# Enabling the Republic of T?rkiye to Prepare Its First Biennial Transparency Report (BTR1) and the Joint Ninth National Communication and Second Biennial Transparency Report (NC9/BTR2) to the UNFCCC

Review CEO Endorsement and Make a recommendation

11313

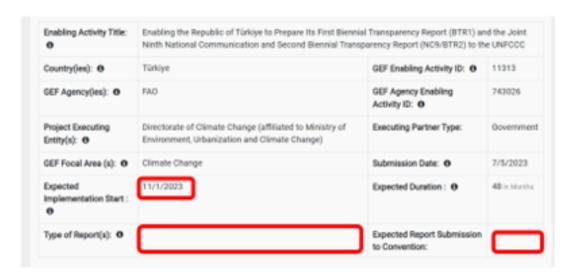
No. Please address the following remaining comment:

3. Please revisit the "Expected Implementation Start Date" to a later date to allow some time for the completion of the review process by both FAO and GEF. The current expected implementation start date of 11/1/2023 is very unlikely to be met.

The proposed start date of the project is adjusted as 1 Jan 2024. Everything is ready to start as soon as ceo-endorsed.
